Application details

Ref: P/OUT/2023/01166	Applicant: Dudsbury Homes (Southern) Ltd.	Case Officer: Ursula Fay
Address: Land to the south of Ringwood Road, Alderholt		
Description: Mixed use development of up to 1,700 dwellings including affordable housing and care provision 10,000sqm of employment space in the form of a business park; village centre with associated retail, commercial, community and health faculties; open space including the provision of suitable alternative natural green space (SANG; biodiversity enhancements; solar array, and new roads, access arrangements and associated infrastructure (Outline Application with all matters reserved apart from access off Hillbury Road).		
Case Officer comments to Consultee:		
Consultee: Colm O'Kelly - Senior Landscape Architect - Infrastructure and Delivery Team		
Date: 27 April 2023		
Has a Pre-application discussion taken place with you?: Yes / No		
Support		
Support subject to condition

Figure 7: Green Infrastructure Parameter Plan

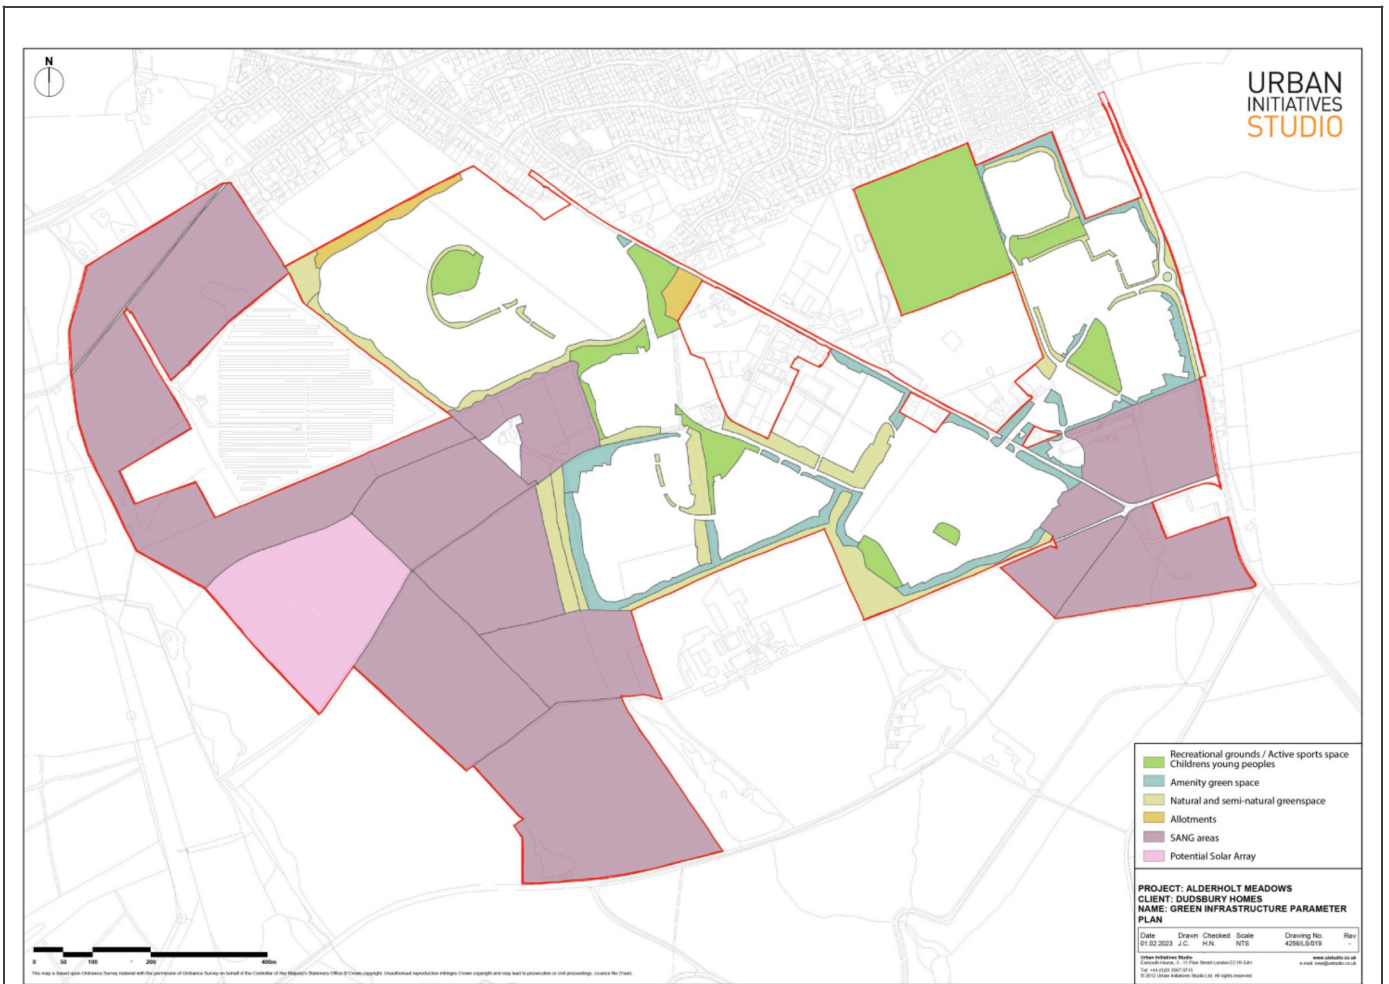
The Green Infrastructure Parameter Plan (**Figure 7**) shows that these neighbourhoods would be surrounded and separated by amenity and semi natural green space, would contain public open spaces of varying sizes and that substantial Sites of Alternative Natural Greenspace (SANGs) would be provided on the western and southeastern boundaries of the site.

I am also generally persuaded that the potential landscape and visual impacts of the proposed development could be mitigated by the provision of SANGs and public open space, and significant amounts of tree planting within them and throughout the proposed residential areas.

Figure 8: Plan indicating existing trees and shrubs to be removed

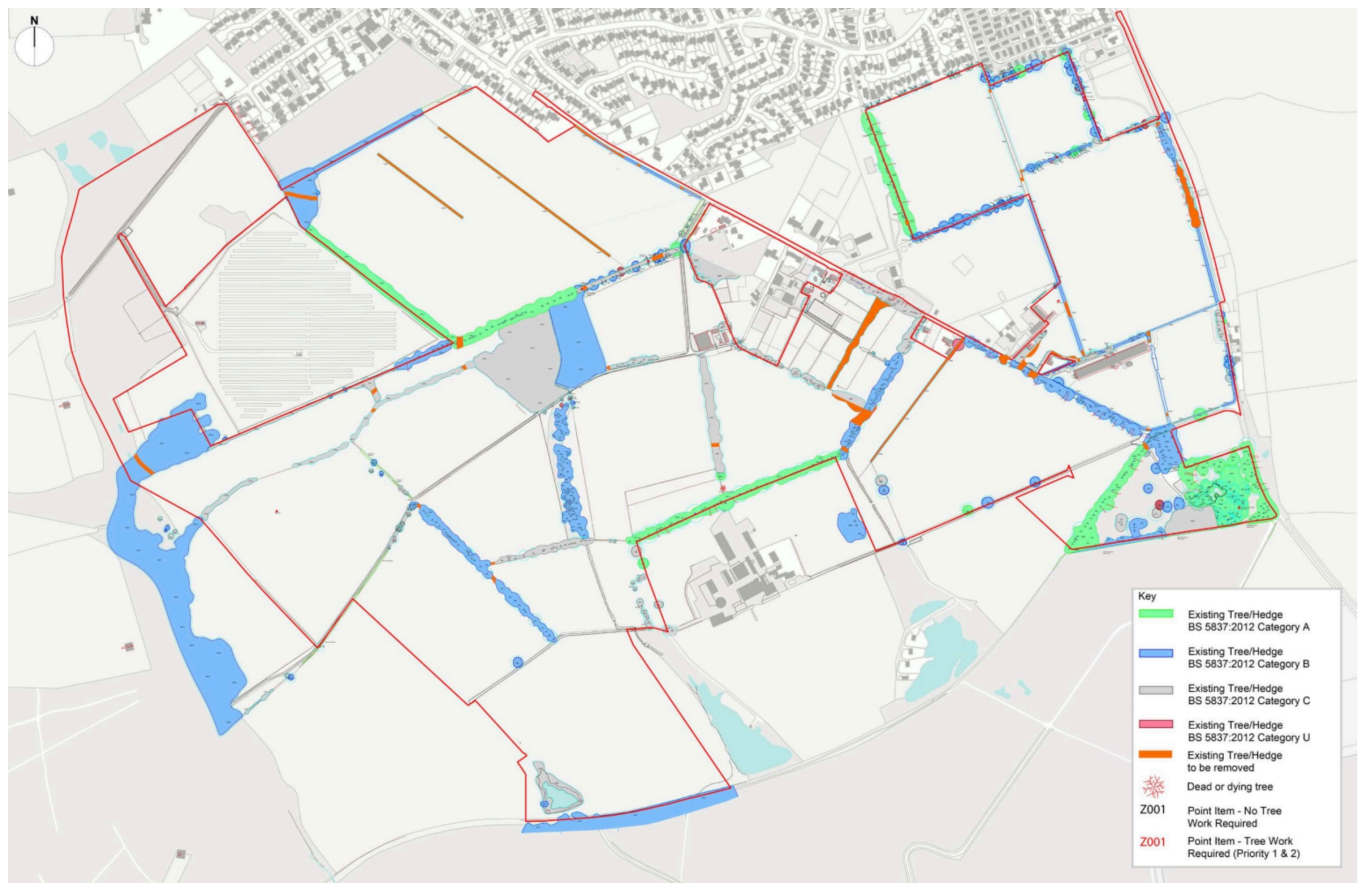
Figure 3.2 within the submitted landscape Strategy (Urban Initiatives Studio January 2023 **Figure 8**) shows that the intention is to retain the majority of existing trees and hedging within and on the boundaries of the site and that they would be incorporated into the proposed development.
